TR010060 – A12 Chelmsford to A120 widening scheme

Mary Ann Lindsay and John Chilcott Lindsay Unique reference nos.: A12C-AFP653 and A12C-AFP654

This submission is supplemental to our previous representations submitted in October 2022.

Laydown Area for Storage of Equipment and Supplies

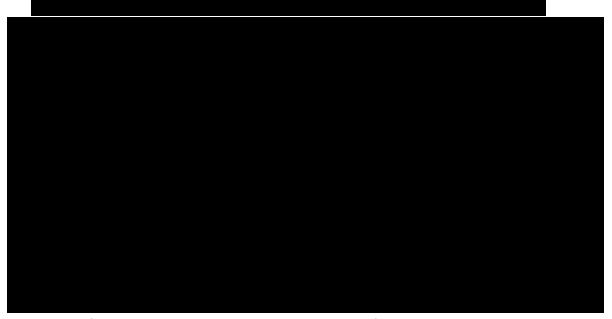
A "Laydown area" is shown on the plan, opposite and in close proximity to our property. This will be a constant source of noise and light pollution disturbing our sleep as our bedrooms overlook it.

We request that the Inspector requires NH to relocate this further away from our house.

View from the B1023 showing our house and front boundary hedge.

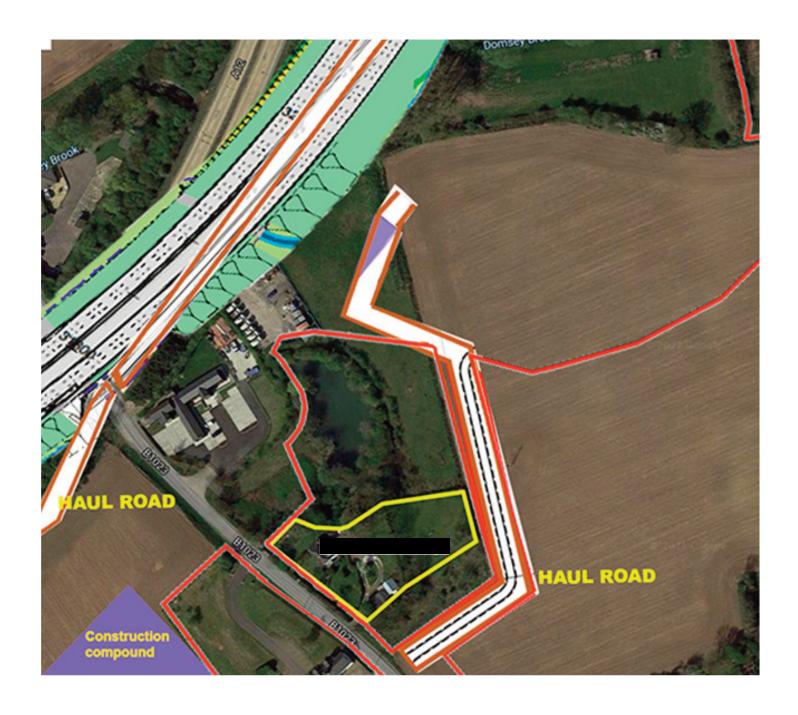
The NH red line indicating order limits on the B1023 appears to encroach on our front boundary hedge.

The hedge was planted over 80 years ago and forms a screen for our home against traffic noise and pollution as well as the increased activity on the B1023 both during and after the scheme.

We request that the Inspector requires NH to give a guarantee that our front boundary hedge will remain intact.

Satellite view showing close proximity of proposed haul roads, compound and widening works.

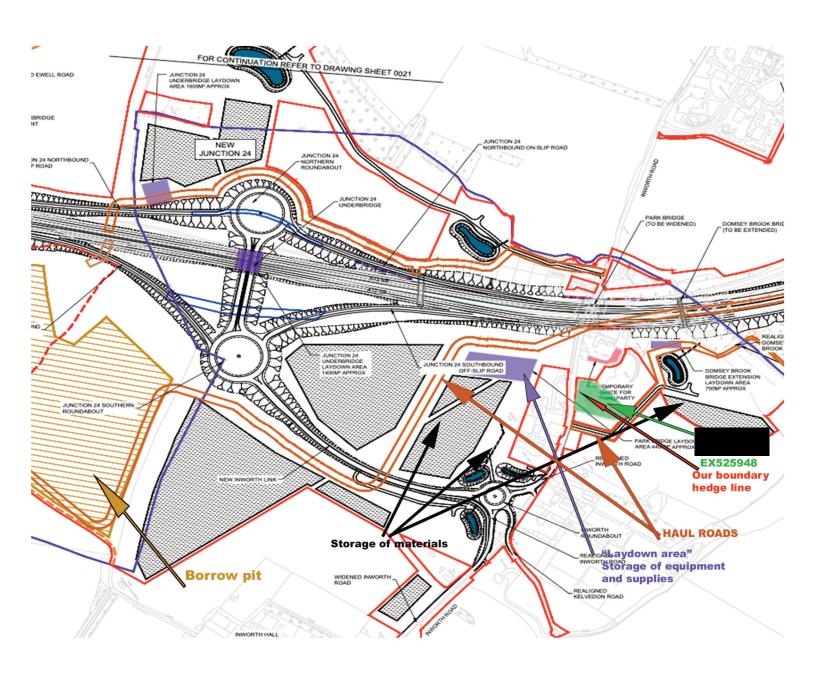
The haul road running along our southeastern boundary was not shown on the original consultation documents and is a very recent feature.

It is not shown how the vehicles using this haul road will access it but it can only be from the B1023.

The heavy vehicles using this haul road traffic will be a constant source of noise vibration and pollution.

We request that the Inspector requires NH not to use this track as a haul road. This would reduce the impact on the peaceful enjoyment of our home and also benefit traffic on the B1023 that will, in any case, be adversely affected by construction work.
